250-266 Danforth St.

Building permit to construct a 7-story masonry building .
186' x 168' with 150 dwelling units at the above named location is
not issuable under the Zoning Ordinance for the following reasons:

Danforth St. High Rise

284 Danforth Street
Harbor Terrace

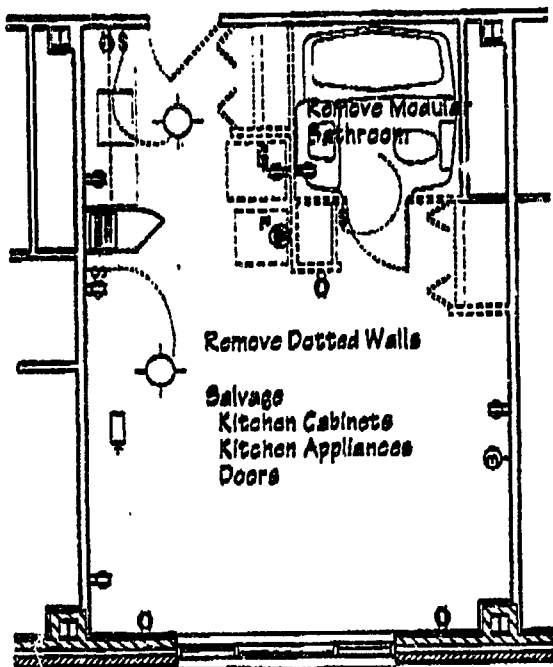
Automatic door: to outside.

*hook-up to emergency generator

self closing device on door to area
of refuge.
